RE: NR-0469-S-113-S

The FDA has classified the selectSeed I-125 as an IIL product (with product code KXK). Therefore, to meet UDI (Unique Device Identifier) compliance, the labelling is required to be modified slightly. To explain the changes, please see attached the new label template specification for the *selectSeed Shipment/Sales Box label (150158-02)*. Additionally, attached is the *Explanation of Symbols on Product Labels (777.00487 MAN)* that will be included in the selectSeed package to explain to the user the meaning of the UDI symbols.

selectSeed labels with UDI implementation

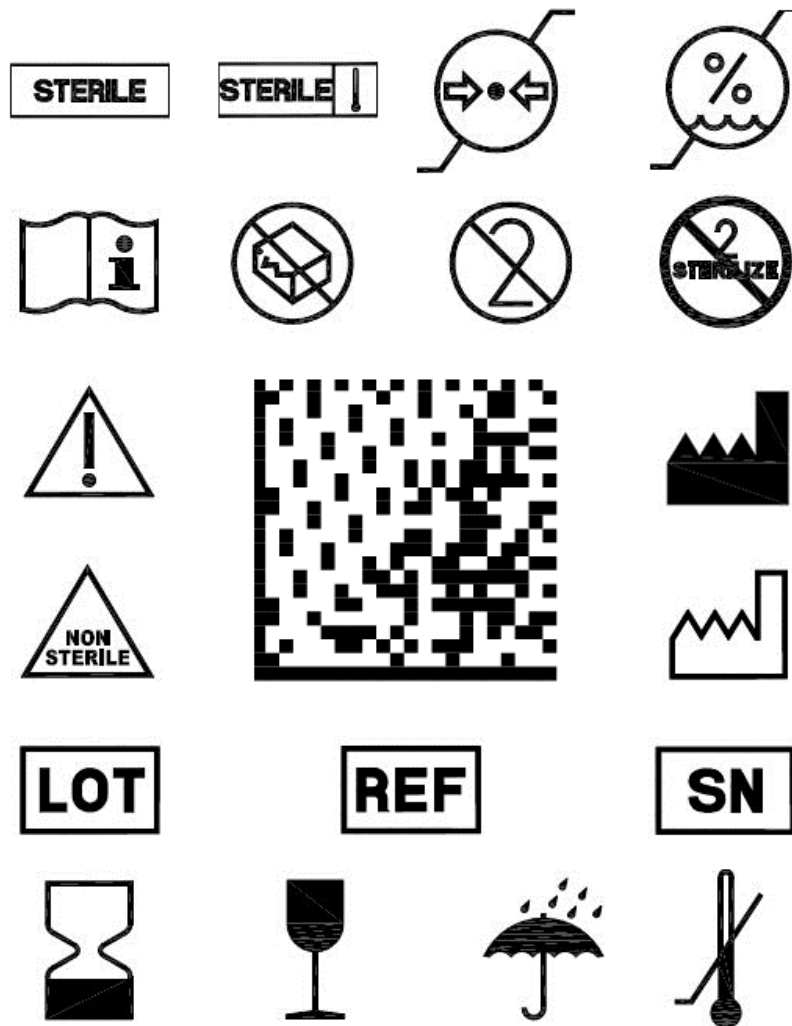
Based on these changes, please amend the Sealed Source and Device Registry, NR-0469-S-113-S, with the updated labels as per the attached document *selectSeed labels with UDI implementation*.
